Portafax

PERSONAL TELEVISION PRODUCT SERVICE, COLLEGE BLVD., PORTSMOUTH, VA.

AUDIO ALIGNMENT PROCEDURE

REAR VIEW OF SOCKET (COVER REMOVED)

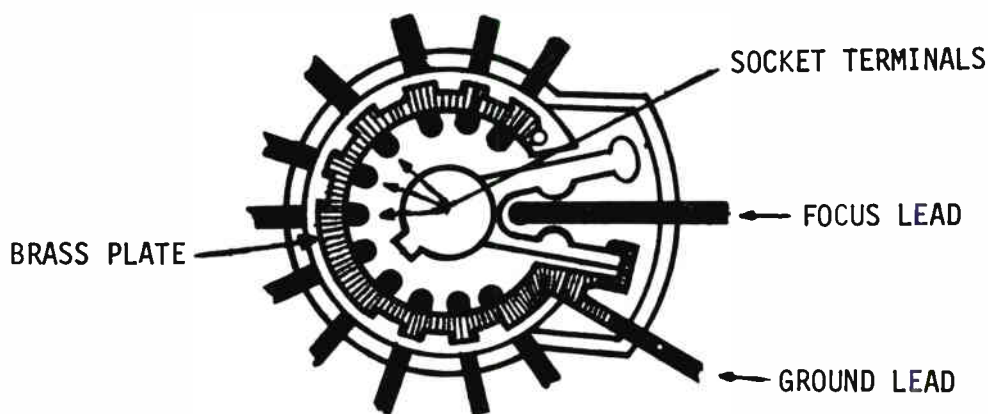
The picture tube socket used in the G-1 Chassis color receiver contains a special built-in spark gap consisting of a grounded brass plate placed close to the socket terminals (see sketch below). An unusually high voltage on a socket terminal will arc to the brass plate rather than to an adjacent terminal, thus protecting the picture tube and its associated components. This is normal, and does not necessarily mean the socket is defective, but usually indicates a problem in associated circuitry.

For example, we have had cases of a continuous arcing condition in the CRT socket caused by an open 47 Meg. resistor (R284) in the focus voltage divider circuit. To obtain best focus, this resistor is connected through a wire jumper to one of three points — B+ boost, +280V, or chassis ground. A bad solder connection at the jumper or an open R284 could cause the voltage on the focus anode terminal (Pin 9) to rise, causing an arc inside the CRT socket.

Should you be called upon to service a G-1 Chassis receiver which has a continuously arcing CRT socket, compare the socket pin voltages to the voltages shown on the schematic diagram. The focus voltage (Pin 9) should be between +3000 volts and +5000 volts with respect to chassis ground. If it is more than 5000 volts, check for an open circuit somewhere between the focus control (R283) and the low potential end of the focus voltage divider circuit.

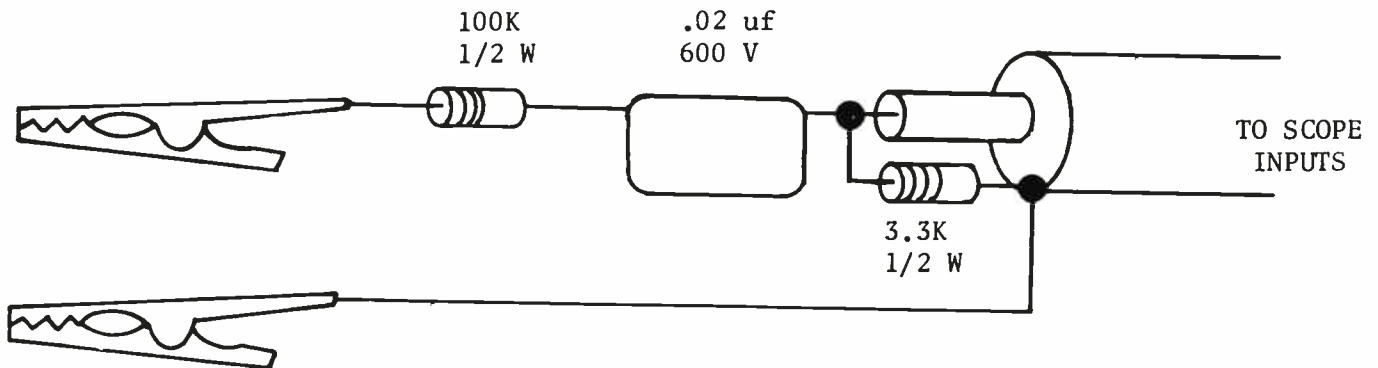
Chassis: TC12" transistor

Problem: Picture tube tilts clockwise, caused by inadequate support at the picture tube right bottom corner.

Correction: Loosen picture tube sling, level picture tube, and wedge an EP3X21 rubber wedge between the right bottom corner of the picture tube and the picture tube sling mounting boss. Tighten picture tube sling.
